# Access Compliance Report

## Public Rights-of-Way

### (Curb Ramps)

Intersection ID: 47123	Main Street: THOMPSON_BROOK_LN	Cross Street: EMMONS_LN	Location: SE
ADA ID: 2C54E588ED41	Ramp Type: BlendTrans1	Initial Pass/Fail: Fail	Overall Compliance: No
		Severity Score: 8.75

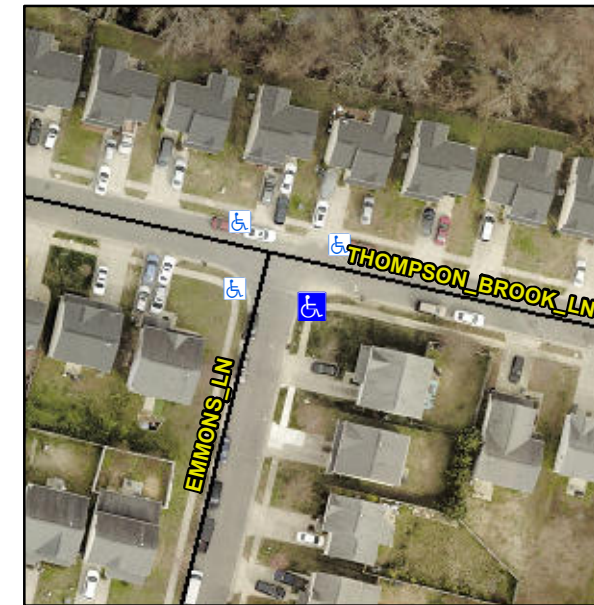
**Not Found, R304.5.1**

Compliance	Description	Data	Compliance	Description	Data
N/A	Ramp Length (in)	46.0	Yes	BlendTrans Slope (%)	4.5
No	Ramp Width (in)	43.0	Yes	BlendTrans XSlope (%)	0.8
N/A	Flare Type LT	N/A	N/A	Flare Type RT	N/A
N/A	Flare Slope LT (%)	N/A	N/A	Flare Slope RT (%)	N/A
N/A	Flare Traversable LT?	N/A	N/A	Flare Traversable RT?	N/A
N/A	Landing Length (in)	N/A	N/A	DWS Provided?	N/A
N/A	Landing Width (in)	N/A	N/A	DWS Contrast?	N/A
N/A	Landing Slope (%)	N/A	N/A	DWS Length (in)	N/A
N/A	Landing X Slope (%)	N/A	N/A	DWS Full Width?	N/A
N/A	Landing Curb? (Y/N)	N/A	N/A	DWS Offset (in)	N/A
N/A	Shared Landing?	N/A			
N/A	Gutter Ponding?	N/A	N/A	Gutter Slope (%)	N/A
N/A	Gutter Lip Ht (in)	N/A	N/A	Gutter X Slope (%)	N/A
N/A	Painted X Walk1?	No	N/A	Painted X Walk2?	No
	X Walk 1 Direction	To NE		X Walk 2 Direction	To NW
	X Walk 1 Width (in)	N/A		X Walk 2 Width (in)	N/A
	X Walk 1 Slope (%)	0.6		X Walk 2 Slope (%)	1.7
	X Walk 1 X Slope (%)	0.0		X Walk 2 X Slope (%)	0.3

N/A	Ramp inside XWalk1?	N/A	N/A	Ramp inside XWalk2?	N/A
	Road Slope (%)	2.3		Clear Space?	N/A
	Road X Slope (%)	0.2	N/A	Clear Space to XWalk (in)	N/A
N/A	Any Obstructions?	N/A	N/A	Storm Grate/Utility Hazard?	N/A
	Obstruction Type			Storm Grate/Utility Type	
		N/A			N/A
			Yes	Surface Condition? (G/P)	Good
			No	Curb Slope (%)	7.4

**Remove & Replace Curb Ramp With Two New Directional Ramps or Equivalent.**
